**Press Release:** BoCC Formally Requests the Suwanee River Water Management District to Re-Evaluate the Increased Flood Zones in East Bronson and to Schedule Additional Opportunities for Public Input

Date of Issue: July 14, 2025

## Proposed Flood Zones in East Bronson: Areas in Red Would Increase to High-Risk Flooding

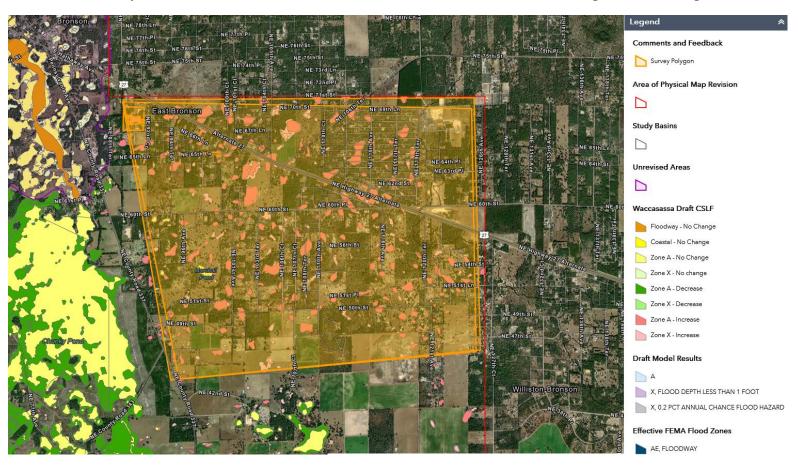
The BoCC expressed particular concern regarding the proposed expansion of designated flood risk areas within East Bronson, where several properties currently classified as Zone X (low risk) are slated for reclassification to Zone A (high risk). In its formal letter, drafted by County Manager Mary-Ellen Harper on behalf of the Board, the BoCC highlighted that many of the areas proposed for reclassification are underlain by Astatula fine sand — a soil type recognized by the Florida Department of Environmental Protection as highly porous and excessively well-drained. The BoCC respectfully requested that the District give further consideration to local soil percolation rates in East Bronson before finalizing any flood zone changes that could unnecessarily impose federal flood insurance requirements on property owners in areas without a documented history of flooding.

I am writing on behalf of the Levy County Board of County Commissioners (BoCC) to express concern about the proposed changes in the flood insurance rate maps. Of particular concern to the BoCC is the increase in designated flood risk areas in East Bronson, where several properties are proposed to be reclassified from X (low risk) to A (high risk). As part of our investigation of this change, we have observed that these areas are well-drained. Reviewing the soil properties for East Bronson from the USDA, the primary soil classification is Astatula fine sand, which has a high porosity and is considered excessively drained soil by FDEP. This is also evident by the limited number of wetlands within this area, as illustrated by the National Wetland Inventory. This reclassification may well cause flood insurance to be federally required for mortgages in an area that does not have a history of flooding. The BoCC respectfully requests that this area be re-evaluated and that additional consideration be given to the soil percolation rates in East Bronson.

Please accept this letter as a formal request to reevaluate the changes to the Flood Insurance Rate Maps for East Bronson and for the district to schedule an evening meeting and two days of office hours at the Levy County Government Center. My contact information is below.
